DUKE POWER COMPANY

Subject: Catawba Nuclear Station, Units 1 and 2
Docket Nos. 50-369 and 50-370
Direct Generation Response Spectra

**RESPONSE TO AUGUST 29, 1989
REQUEST FOR ADDITIONAL INFORMATION**

Figure 1

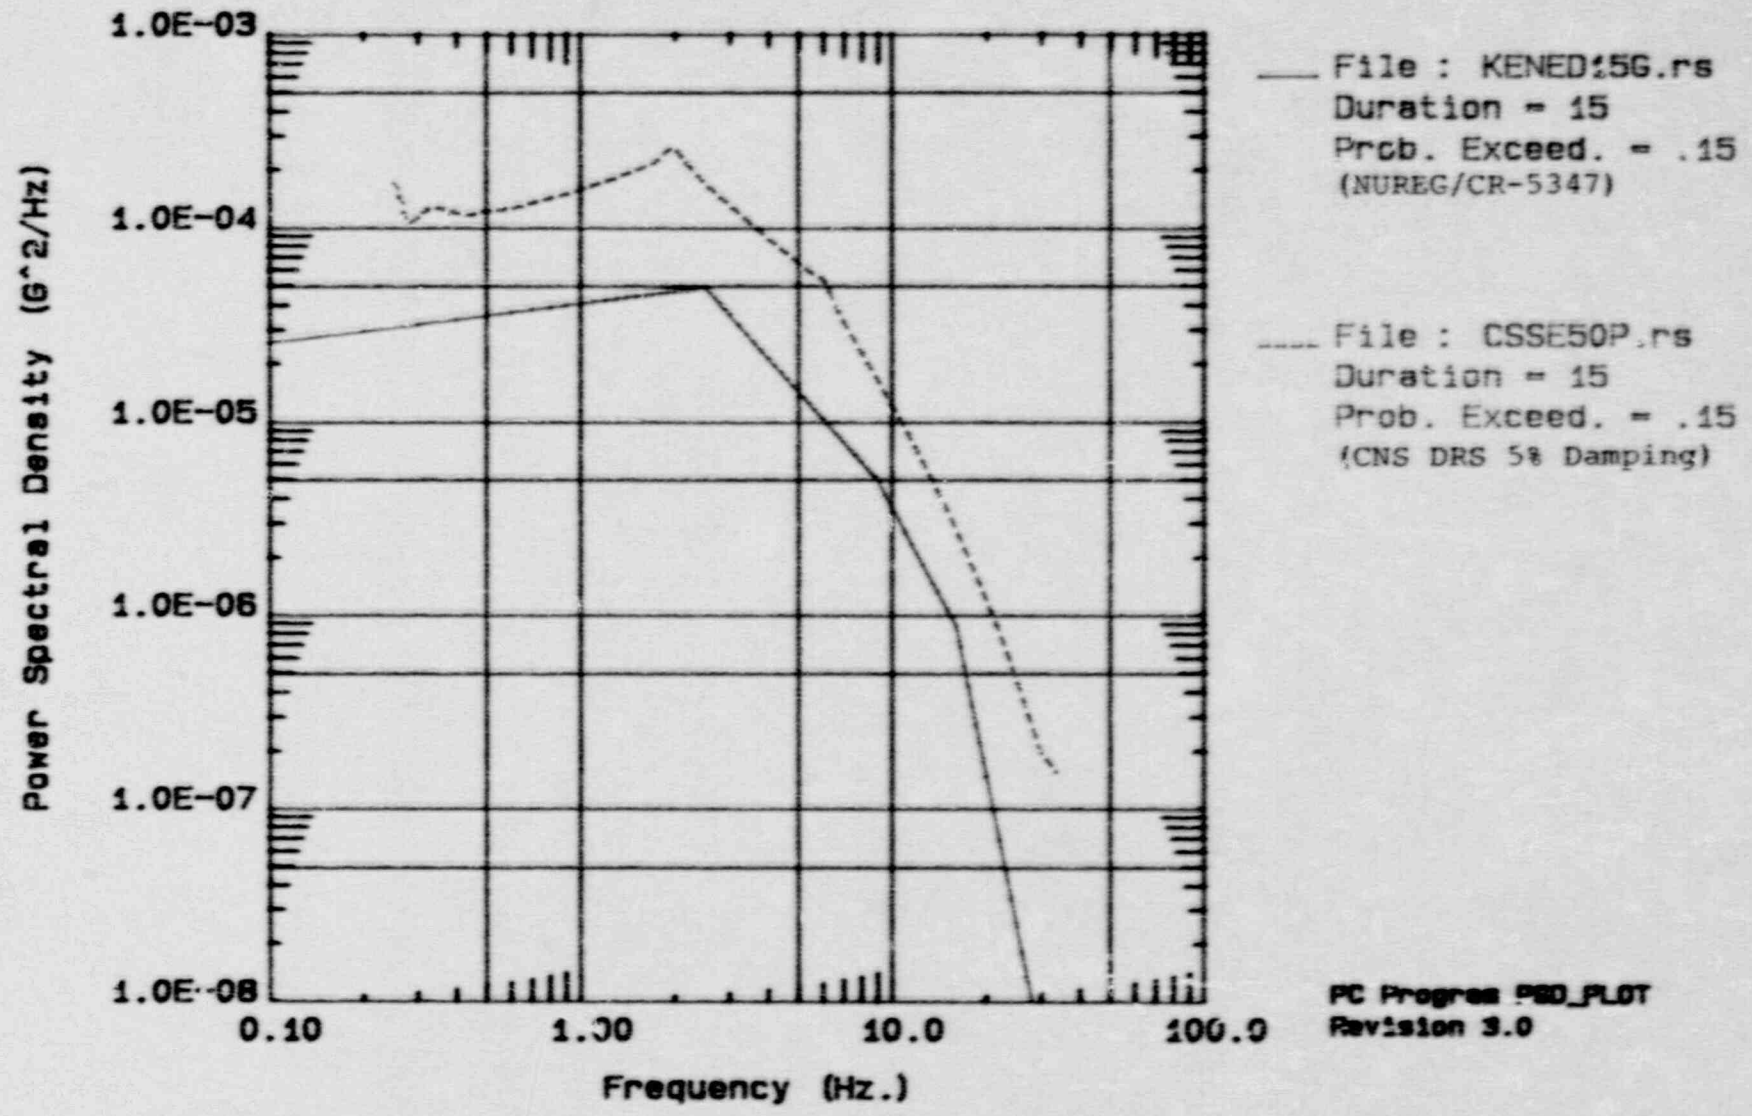
1. In references 2 and 3, the staff had suggested two options which Duke Power can use to demonstrate the appropriateness of the input response spectra. The latest submittal (reference 1) neither discusses these options nor provides any additional bases for the use of the Catawba ground response spectra (CNS-GRS). Table 1 of reference 4 clearly indicated that the system responses calculated using the site-specific spectra could be as high as 18% above the responses calculated using the CNS-GRS. For some yet to be analyzed systems, the differences could be still higher. Therefore, the staff requests that Duke Power provide information as to how the input spectra conservatively represent the site characteristics.

2. Reference 1 indicates that Duke Power is aware of the potential resolution of public comments on the proposed resolution of USI A-40 (revision to SRPs 2.5.2, 3.7.1, 3.7.2, 3.7.3). It should be noted, however, that the assessment of the adequacy of power is still required. It is more critical when the input response spectra do not represent the site characteristics adequately. Target power spectral density function (PSDF) developed using the site-specific data and the recommendations of NUREG/CR 5347, Appendix B, is acceptable. Duke Power is requested to provide information to demonstrate that the CNS-GRS would satisfy the minimum PSDF criteria.

The use of the Newmark Spectra alone, anchored at 0.15g, meets the minimum power spectral density requirements as outlined in NUREG/CR 5437, Appendix B. This is illustrated in Figure 1 which shows the PSD from the Newmark Spectra exceeding the minimum requirements from the referenced NUREG at all frequency points.
